Title: Advisory Committee on Reactor Safeguards  
Power Uprates Subcommittee - Open Session

Date: June 22, 2012

POWER UPRATES SUBCOMMITTEE

9 MR. JENSEN: Okay. Now that we've  
10 overcome that technical difficulty, I'll get started.  
11 Good morning. My name is Joe Jensen. I am the Site  
12 Vice President for the St. Lucie nuclear power plant.  
13 I want to thank the Subcommittee for the opportunity  
14 to speak on behalf of Florida Power and Light  
15 regarding the extended power uprate of St. Lucie Unit  
16 2.

# LEFM ✓ + System Overview

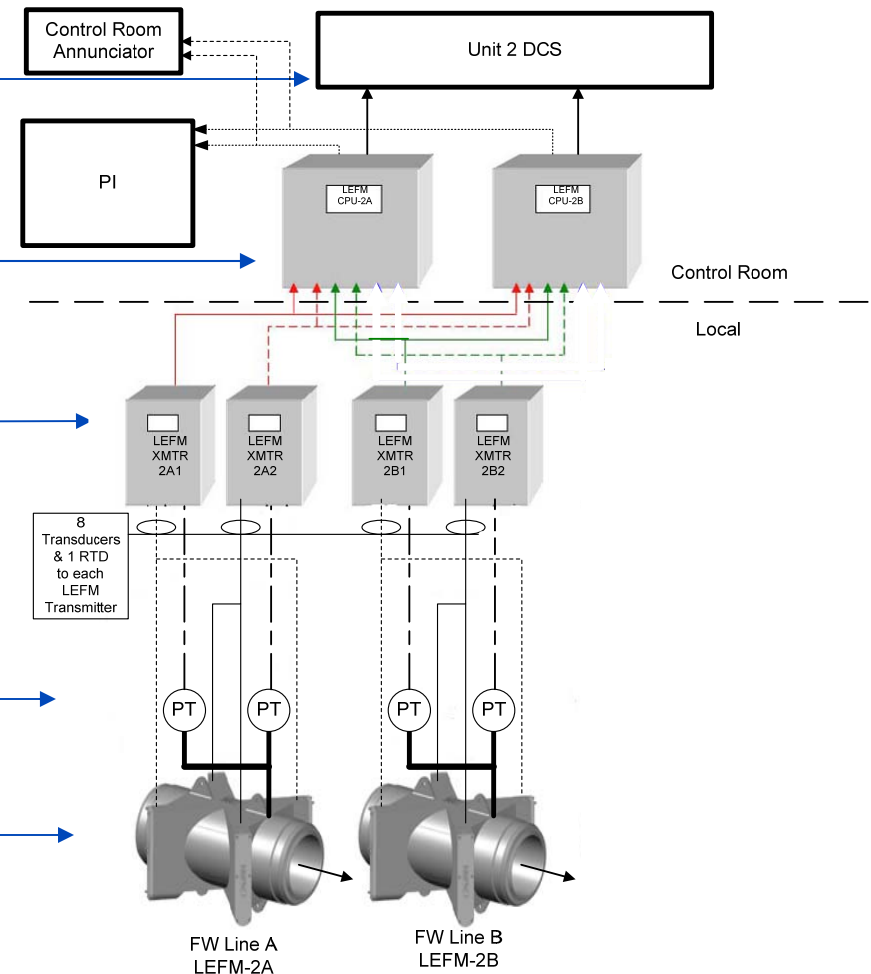
19 MEMBER BROWN: So in the absence of  
20 diagrams and some architectural representation of  
21 where this information goes to, it gives the clear  
22 impression it just disappears out of the plant and  
23 gets siphoned off via some Ethernet connection to  
24 outside world, the Internet, corporate world,  
25 whatever.

1           There was no mention, relative to the  
2           cybersecurity, what type of reg guides or what  
3           interfaces govern, for instance, RG 5.71, which lays  
4           out a level of isolation for critical plant data,  
5           which this is. It also leaves open the question about  
6           whether somebody could get in and modify that data as  
7           it is being presented to the operators, if you've got  
8           an Ethernet connection coming into the DCS.

9           So I don't know how you're going to  
10          explain all that in this particular meeting, but I did  
11          want to make you aware that somewhere along the line,  
12          I would like to get a clear understanding of why  
13          nobody is ever going to be able to get in. RG 5.71  
14          makes it fairly clear that if you're going to  
15          communicate outside the main plant, it should be a one  
16          way only communication link.

9 MEMBER BROWN: Or whether it has access,  
10 people can actually access it and tell the PI system  
11 to do things or provide information to them. Because  
12 if you're connecting with that via the Ethernet system  
13 as well, then you're just daisy-chaining the dual bi-  
14 directional communications all the way into the plant.

4 MR. HOFFMAN: Yeah. Let me just add on to  
5 what Steve has said. Several years back, going from  
6 analog to digital technology, we implemented a  
7 distributed control system is what we call it or DCS  
8 in the control room, that provides the operator --  
9 there's a number of different systems that communicate  
10 with the Distributed Control System in the control  
11 room, to provide operators with much better  
12 information, touch screens and what-not, and that is  
13 isolated from the outside world.

14 That is a system that is specific and does  
15 not communicate outside the control room. The way we  
16 implemented the Leading Edge Flow Meter modification  
17 is we simply, using the DCS as the what I'll call the  
18 brains to do the calorimetric calculation, the outputs  
19 of the LEFM provides the inputs into the DCS to do the  
20 calorimetric calculation.

21 The calorimetric information is displayed  
22 in the control room. The calculated calorimetric  
23 information is displayed in the control room, and  
24 that's not communicated with the outside. That  
25 information, correct me if I'm wrong Todd, is used by
